APPLICATION NO.	FILING DATE	FIRST NAMED INVENTOR	ATTORNEY DOCKET NO.	CONFIRMATION NO.
Ī	16/807,146	03/02/2020	Ted Thomas	NPL-20-03-01	1058
	143866 Nelson Patent L	7590 09/29/202	1	EXAMINER	
	2283 Lalique C	Cir.		DIGNAN, MICHAEL L	
	Colton, CA 923	524		ART UNIT	PAPER NUMBER
				1723	
				NOTIFICATION DATE	DELIVERY MODE
				09/29/2021	ELECTRONIC

Application No.	Applicant(s)					
	16/807,146	Thomas, Ted					
Office Action Summary	Examiner	Art Unit	AIA (FITF) Status				
	MICHAEL L DIGNAN	1723	Yes				
The MAILING DATE of this communication appears on the cover sheet with the correspondence address							
Period for Reply							
A SHORTENED STATUTORY PERIOD FOR REPLY IS SET TO EXPIRE 3 MONTHS FROM THE MAILING DATE OF THIS COMMUNICATION. - Extensions of time may be available under the provisions of 37 CFR 1.136(a). In no event, however, may a reply be timely filed after SIX (6) MONTHS from the mailing							
 date of this communication. If NO period for reply is specified above, the maximum statutory period w Failure to reply within the set or extended period for reply will, by statute, Any reply received by the Office later than three months after the mailing adjustment. See 37 CFR 1.70

FIG. 10A

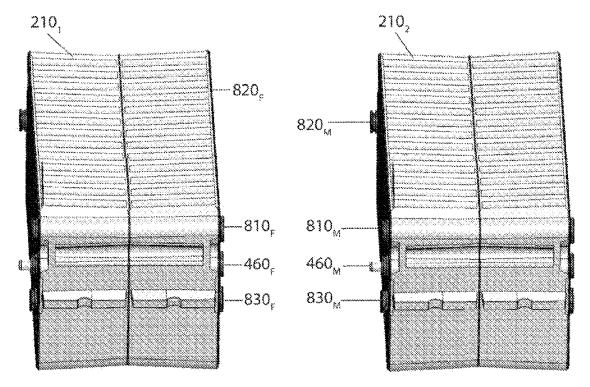
Claims *** are rejected under 35 U.S.C. 102(a)(1) as being anticipated by Harris (US 2018/0358667 to Harris et al.).

Regarding Claim 1, Harris teaches:

- a stackable battery system with at least two bussing housings 210 (Fig. 10, paras 0046-0048)
- each housing having a top electrical connector 460M and a bottom electrical connector 460F
 designed to mate with the top connector of another housing (Fig. 10A, para 0047)
- a top mechanical connector 810M and a bottom mechanical connector 810F operable to hold said bussing housing motionless in at least one dimension relative to another bussing housing when in close proximity (see Fig 10A showing mechanical interference fit for the two ports 820, and para 0048)
- at least one battery cell connected to each bussing housing (claim 1, para 0043, etc.)
- wherein said bussing housing together form a stacked batter module (Fig. 10A)
